CY7C129*DV18/CY7C130*DV25
 CY7C130*BV18/CY7C130*BV25/CY7C132*BV25
 CY7C131*BV18 / CY7C132*BV18/CY7C139*BV18
 CY7C191*BV18/CY7C141*AV18 / CY7C142*AV18/
 CY7C151*V18 /CY7C152*V18

Errata Revision: *C

RAM9 QDR-I/DDR-I/QDR-II/DDR- II Errata

QDR/DDR $\overline{\text{DOFF}}$ Pin, Output Buffer and JTAG Issues Errata Summary

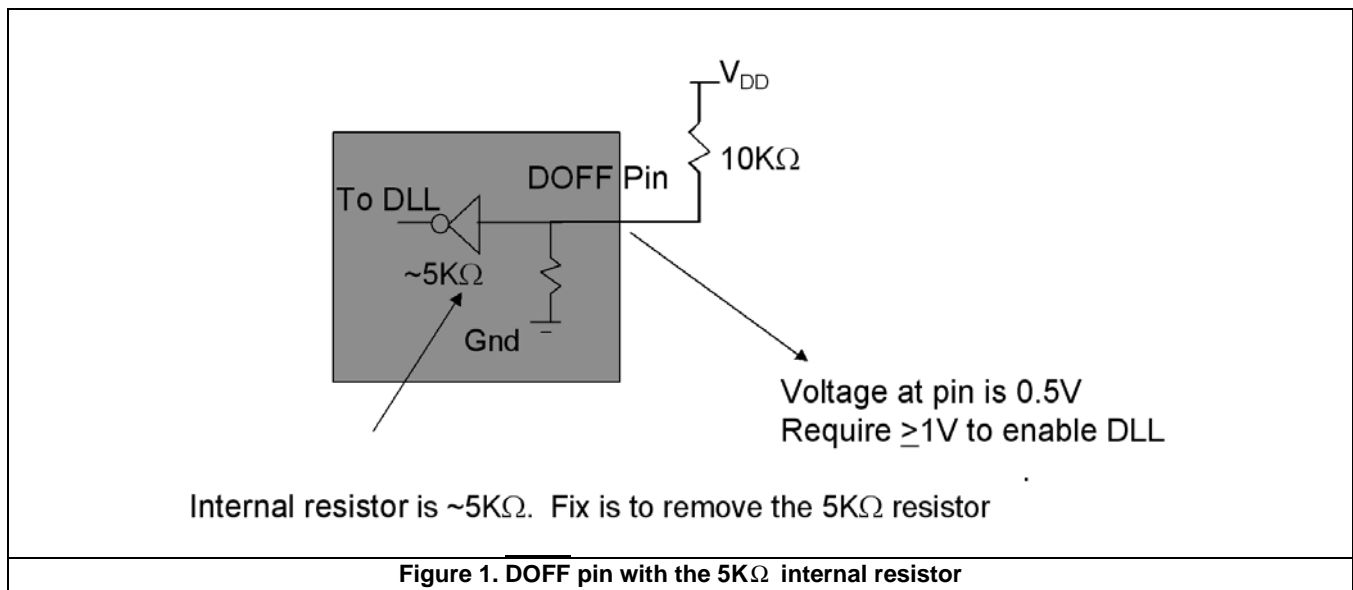
This issue involves the DLL not turning ON properly if a large resistor is used (eg:-10K Ω) as an external pullup resistor to enable the DLL. If a 10K Ω or higher pullup resistor is used externally, the voltage on DOFF is not high enough to enable the DLL.

Figure 1 shows the DOFF pin circuit with an internal 5K Ω internal resistor. The fix planned is to disable the internal 5K Ω leaker.

Fix involved removing the internal pull-down resistor on the $\overline{\text{DOFF}}$ pin. The fix has been implemented on the new revision and is now available. The new revision is an increment of the existing revision. The following table lists the devices affected, current revision and the new revision after the fix.

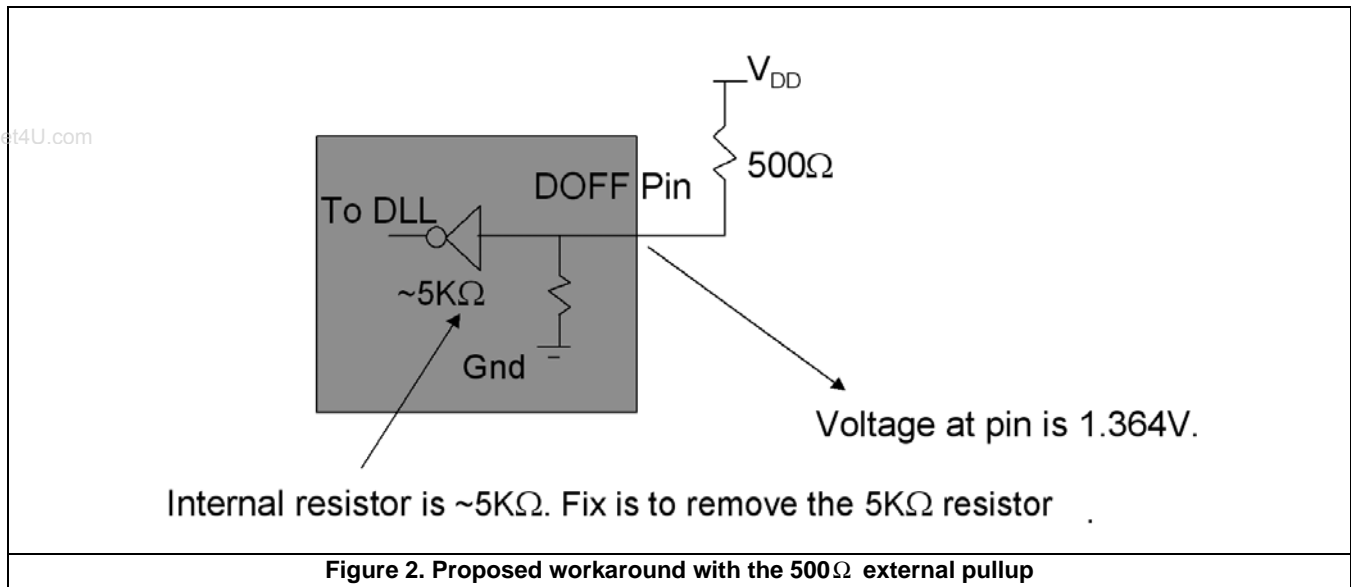
The workaround is to have a low value of external pullup resistor for the $\overline{\text{DOFF}}$ pin (recommended value is $\leq 500\Omega$). When $\overline{\text{DOFF}}$ pins from multiple QDR devices are connected through the same pull-up resistors on the board, it is recommended that this $\overline{\text{DOFF}}$ pin be directly connected to V_{DD} due to the lower effective resistance since the "leakers" are in parallel.

Figure 2 shows the proposed workaround and the fix planned.

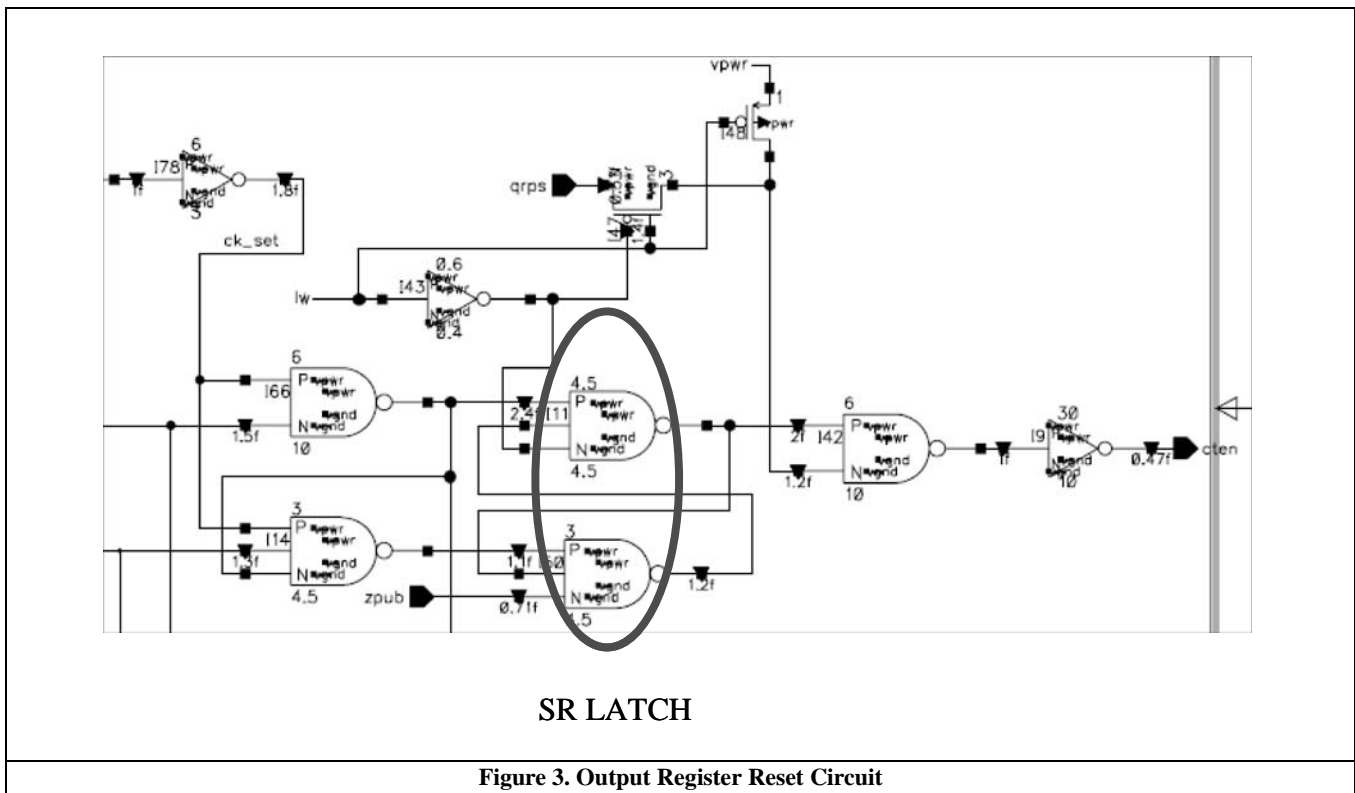
This issue involves the output buffer entering an unidentified state when the input signals (only Control signals or Clocks) are floating during reset or initialization of the memory controller after power up.

Figure 3 shows the output register Reset circuit with an SR Latch circled. This latch has two inputs with one of them coming from some logic affected by the clock and RPS#(QDR) or WE# and LD#(DDR). The issue happens when clocks are glitching/toggling with controls floating. This will cause the SR latch to be taken into an unidentified state. The SR Latch will need to be reset by a dummy read operation if this happens.

The fix has been implemented on the new revision and is now available. The new revision is an increment of the existing revision. Please refer to Table 4 for the list of devices affected, current revision and the new revision after the fix.

Figure 4. Dummy Read Implementation

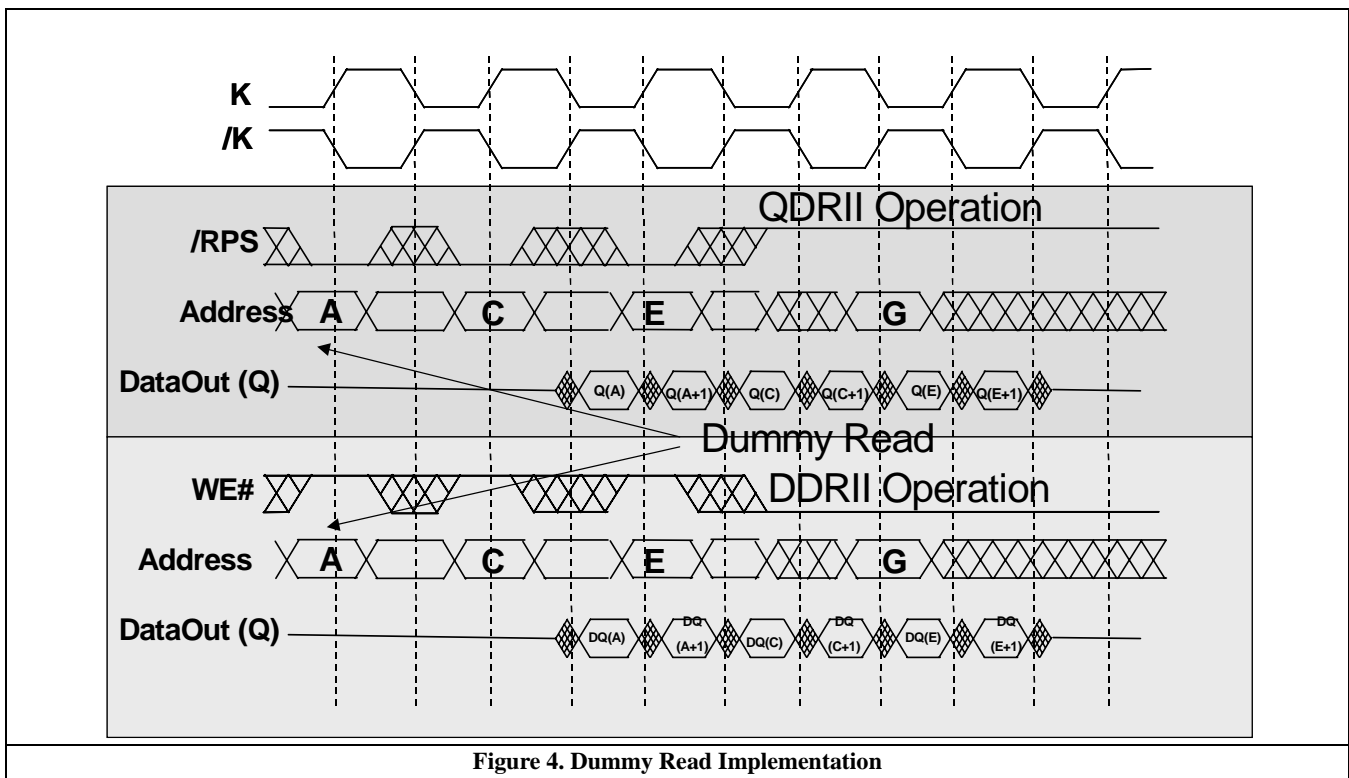
This is viable only if the customer has the trigger conditions met during reset or initialization of the memory controller after power up. In order for the workaround to perform properly, Cypress recommends the insertion of a minimum of 16 “dummy” READ operations to every SRAM device on the board prior to writing any meaningful data into the SRAM. After this one “dummy” READ operation, the device will perform properly. “Dummy” READ is defined as a read operation to the device that is not meant to retrieve required data. The “dummy” READ can be to any address location in the SRAM. Refer to Figure 4 for the dummy read implementation.

- 1) For the 72M / 36M / 18M x9 devices drive address pin A2 / A10 / A3 low respectively and perform dummy read.
- 2) For the 72M / 36M / 18M x9 devices drive address pin A2 / A10 / A3 high respectively and perform dummy read.
